Letter Number 2.18.004

Description and Evaluation of the Proposed Changes

**SUBJECT:** Revise the Pilgrim Emergency Plan to Address the Permanently Defueled Condition

Figure B-1a: PNPS Emergency Response Organization Management Leads

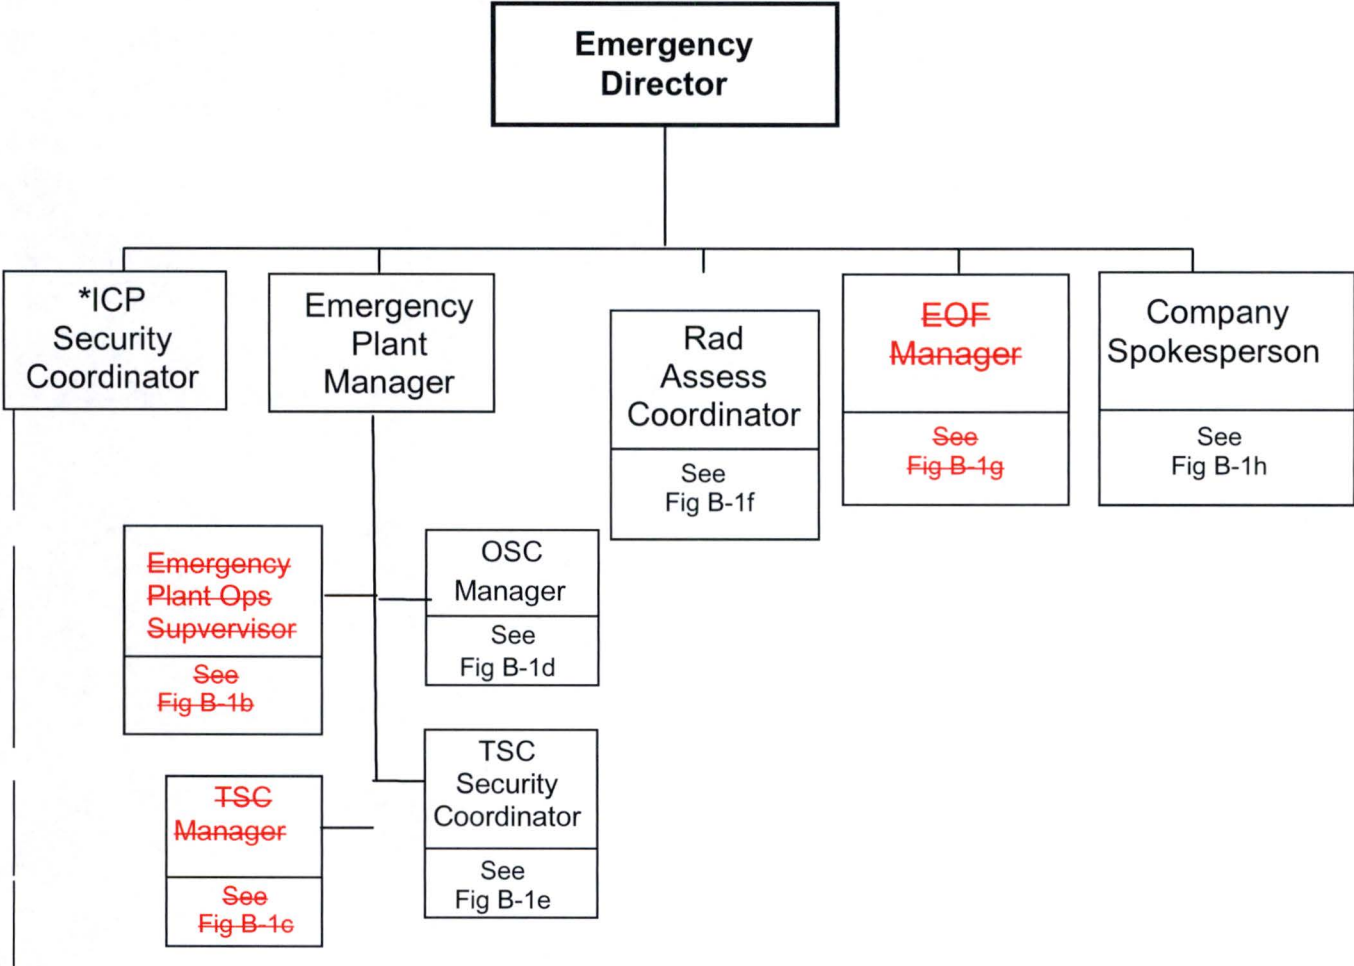
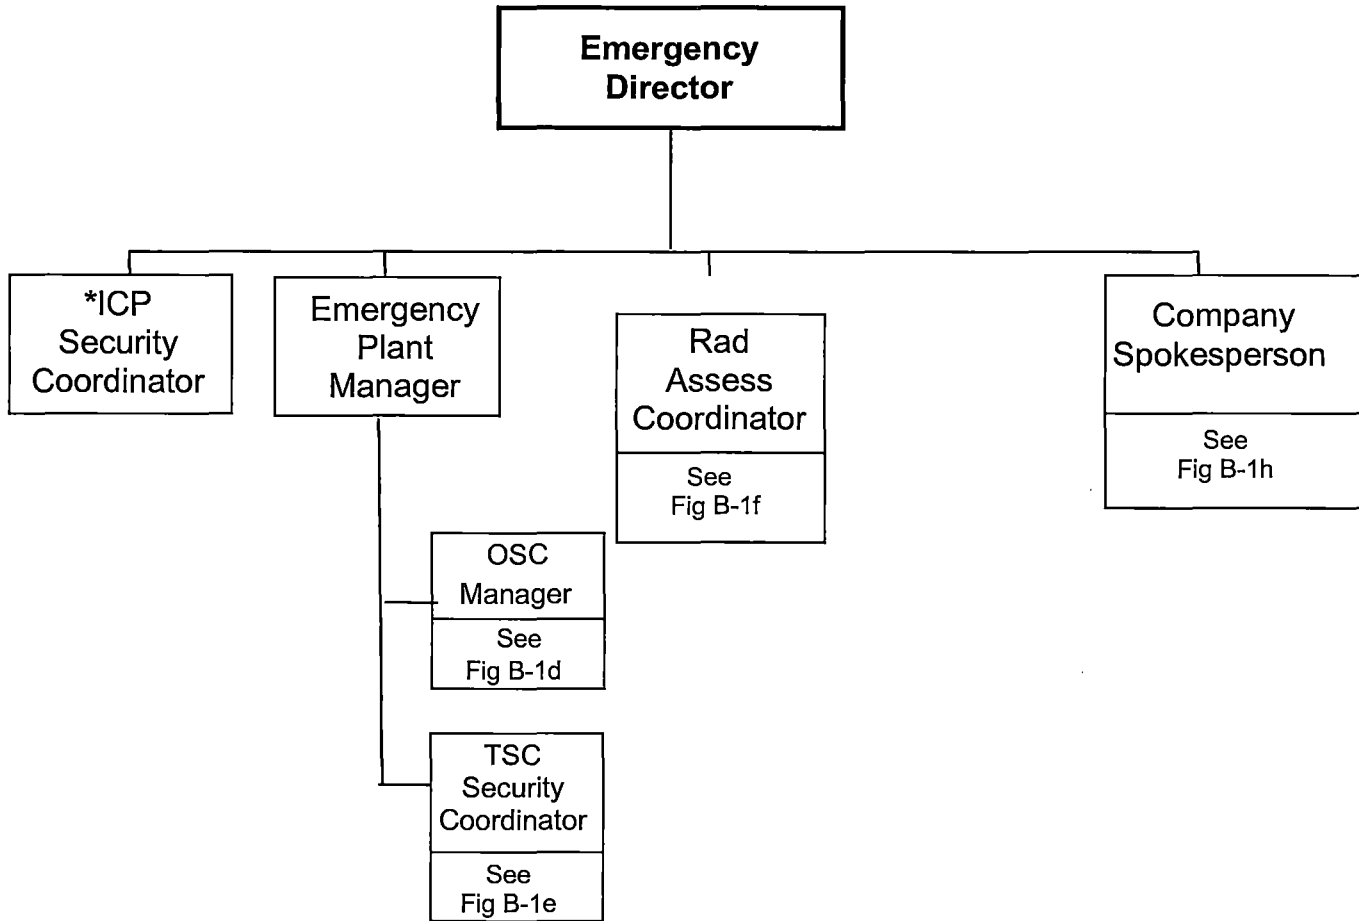
Part 2, Figure B-1a	PNPS Emergency Response Organization Management Leads	Deleted the following: EOF Manager TSC Manager See Fig B-1b	The positions of EOF Manager and TSC Manager will no longer exist in the Permanently Defueled ERO. Duties and responsibilities will be transferred to remaining positions within the respective facilities.
Part 2, Figure B-1b	Operations Emergency Organization	Deleted the figure	PNPS will no longer be an operating nuclear power plant. Following permanent cessation of operations and removal of fuel from the vessel, Operations on-shift personnel will consist of one CRS and two NCOs. Title changes are dependent upon NRC approval of changes to the PNPS Technical Specifications that will replace references to licensed and non-licensed operators with references to CFHs and NCOs.  These staffing levels have been evaluated in the PNPS analysis of proposed post-shutdown on-shift staffing in conjunction with the

Figure B-1b: Operations Emergency Organization

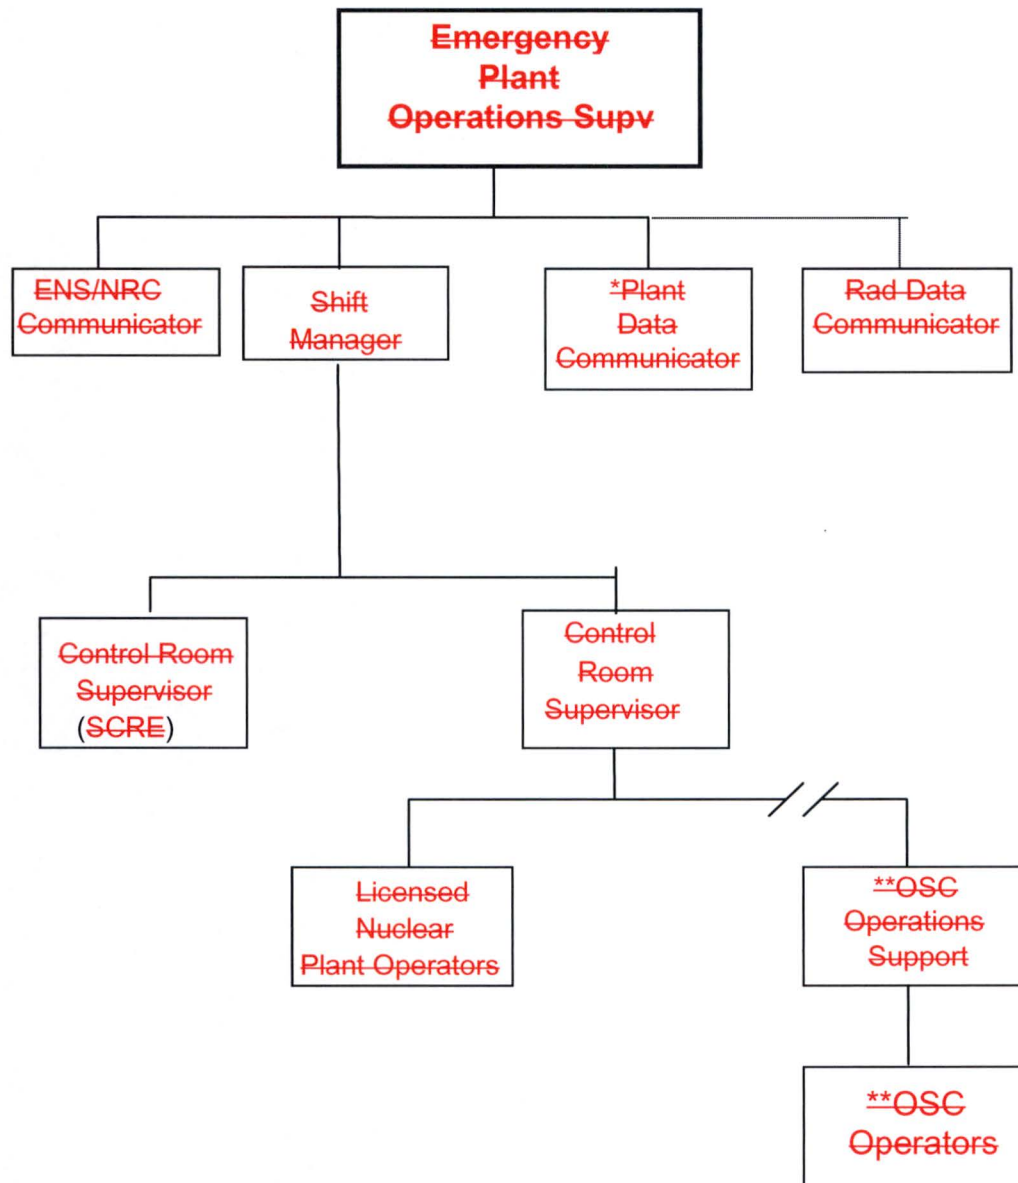
Augmented ERO positions responding to the Control Room are no longer necessary in the permanently shut down and defueled condition. Therefore, the proposed changes to the PNPS SEP will also eliminate Figure B-1b, "Operations Emergency Organization." Proposed changes to the Control Room Augmenting Positions are discussed in Section 3.2.2.5.

PNPS SEP Figure B-1b, "Operations Emergency Organization" illustrates the Operations Emergency Organization, including augmenting positions that respond to the Control Room following an emergency declaration. PNPS SEP Part 2, Section B.1.b.5 describes the Emergency Plant Operations Supervisor as the senior management position in the Control Room responsible for coordination of the Control Room activities with all outside emergency facilities. The Emergency Plant Operations Supervisor does not relieve the Shift Manager of responsibilities for operation of the plant. This position advises the Emergency Plant Manager on plant status and trends and their potential impact. The Emergency Plant Operations Supervisor interfaces with the TSC Manager, OSC Manager, Radiological Coordinator, and the TSC Security Coordinator.

Figure B-1c: Defueled Technical Support Organization

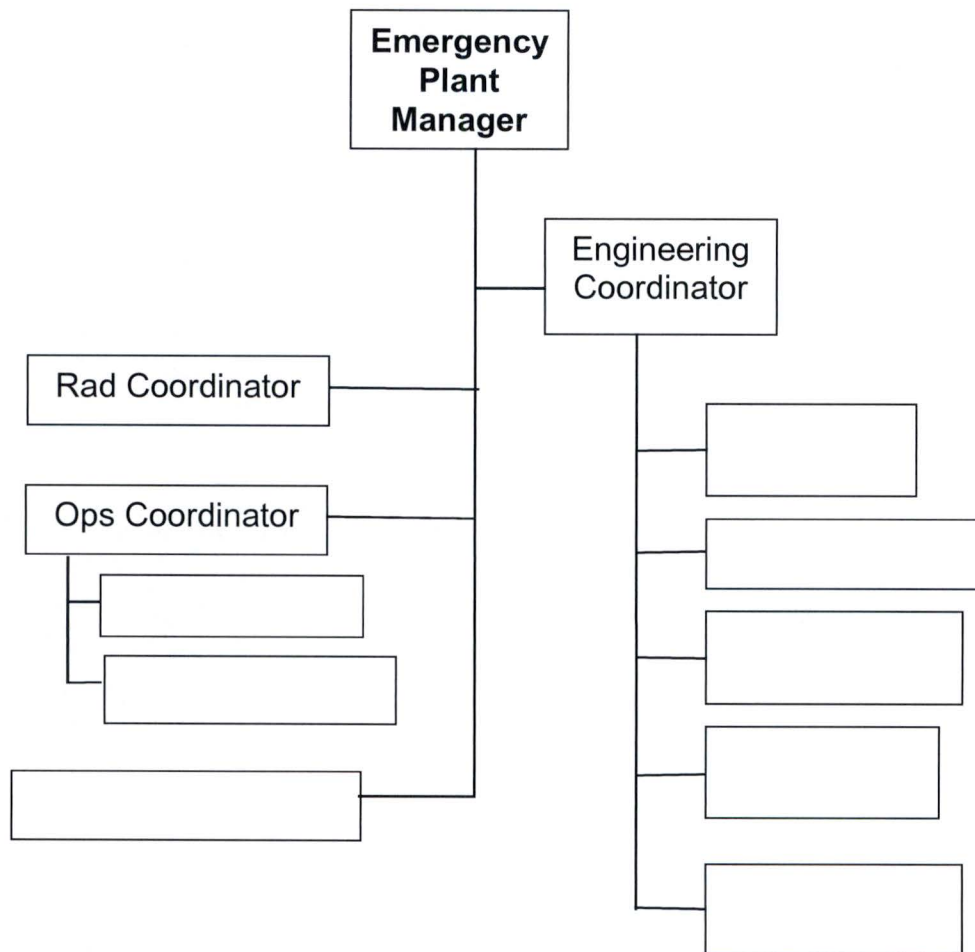
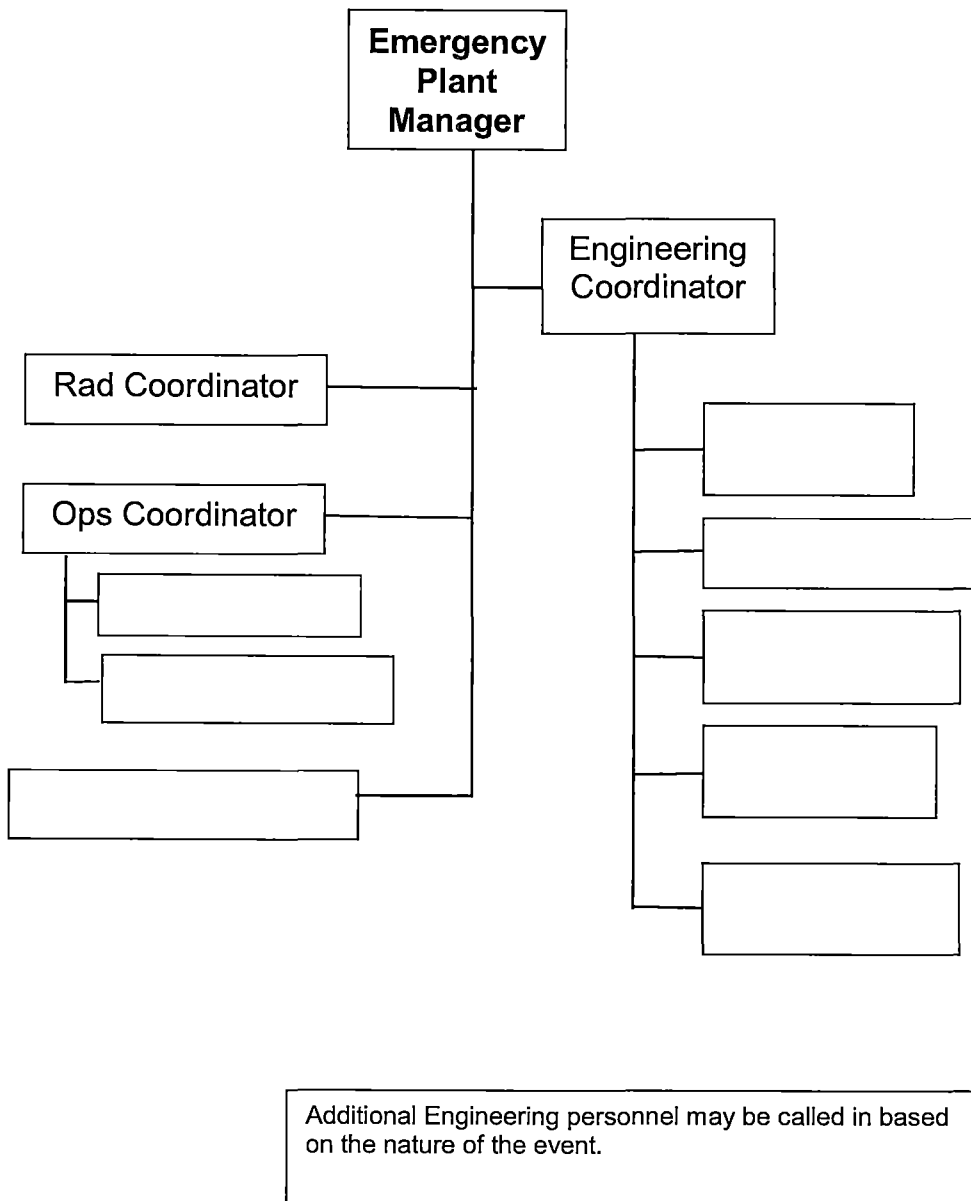
Emergency Plan Section	Before (Rev. 48)	After (Rev. TBD)	Reason for Change
			postulated accidents that will be applicable in the permanently defueled condition.
Part 2, Figure B-1c	Technical Support Organization	Defueled Technical Support Organization	PNPS will no longer be an operating nuclear power plant. The title change reflects the permanently defueled organizational structure.
Part 2, Figure B-1c	Technical Support Organization	<p>Replaced TSC Manager with Emergency Plant Manager</p> <p>Deleted the following positions:  Ops Engineer  SCRE  TSC Communicator  Electrical Engineer  I&amp;C Engineer  Mechanical Engineer  Reactor Engineer  IT Specialist</p> <p>Deleted NOTE: SCRE – Control Room Supervisor (SCRE)</p>	These positions will no longer exist in the Permanently Defueled ERO. Duties and responsibilities will be transferred to remaining positions within the Technical Support Organization.

Figure B-1d: ~~Defueled~~ Operations Support Organization

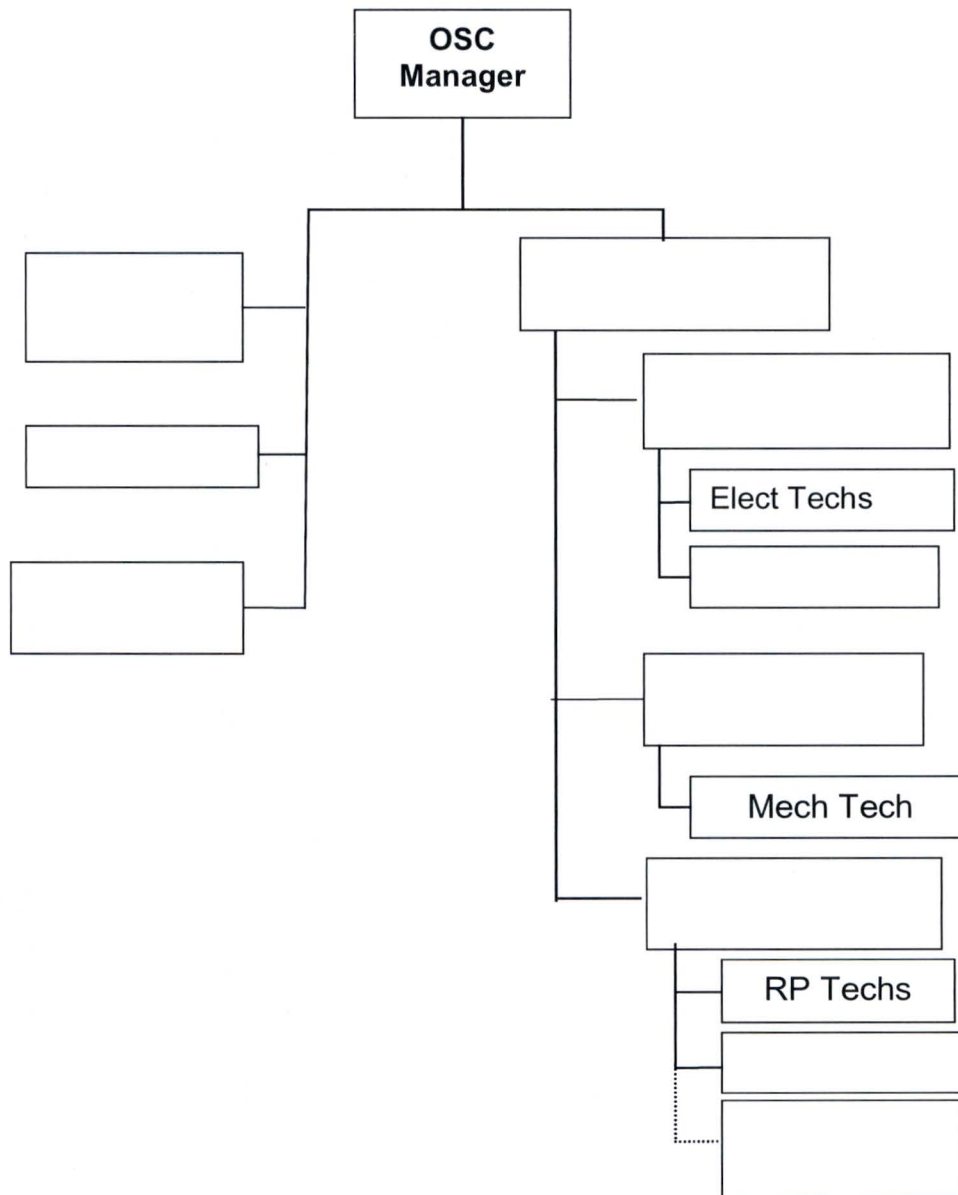
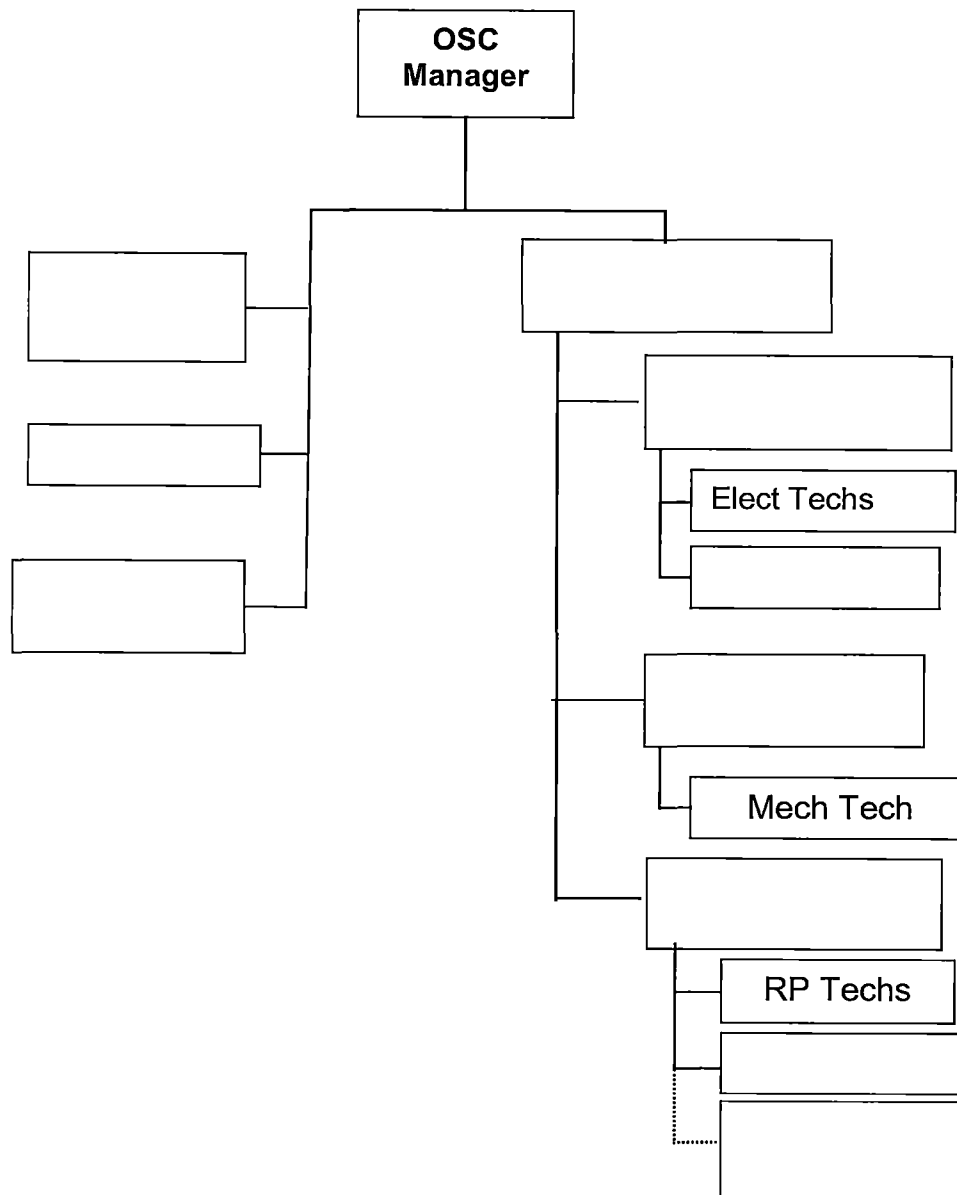
Part 2, Figure B-1d	Operations Support Organization	Defueled Operations Support Organization	PNPS will no longer be an operating nuclear power plant. The title change reflects the permanently defueled organizational structure.
Part 2, Figure B-1d	Operations Support Organization	<p>Deleted the following positions:  Ops Support  Logkeeper  Dosimetry Clerk  Work Control Coordinator  I&amp;C/Electrical Coordinator  Mechanical Coordinator  Rad/Chem Coordinator  I&amp;C Techs</p>	The spectrum of credible and operational events, and the quantity and complexity of activities required for the safe storage of spent nuclear fuel is reduced as compared to an operating plant. The set of plant equipment required in the permanently defueled condition is also greatly reduced, which reduces

Emergency Plan Section	Before (Rev. 48)	After (Rev. TBD)	Reason for Change
		Chem Tech Rad Data Communicator  Deleted NOTE: Rad Data Communicator only if SPDS is inoperable.	the repair and corrective action activities the OSC must perform.
		Deleted the Rad Data Communicator  Deleted NOTE: Rad Data Communicator only if SPDS is inoperable.	
Part 2, Figure B-1g	Emergency Operations Facility Organization	Deleted the following positions: EOF Manager Admin and Logistics Coordinator IT Specialist Public Information Liaison EOF Communicator Log Keeper  Changed: "Offsite Liaison(s)" to "Offsite Liaison" "Dose Assessors" to "Dose Assessor" "Located at Commonwealth and Local EOCs" to "Located at Commonwealth and Plymouth EOCs"	These positions will no longer exist in the Permanently Defueled ERO. Duties and responsibilities will be transferred to remaining positions within the Emergency Response Organization.
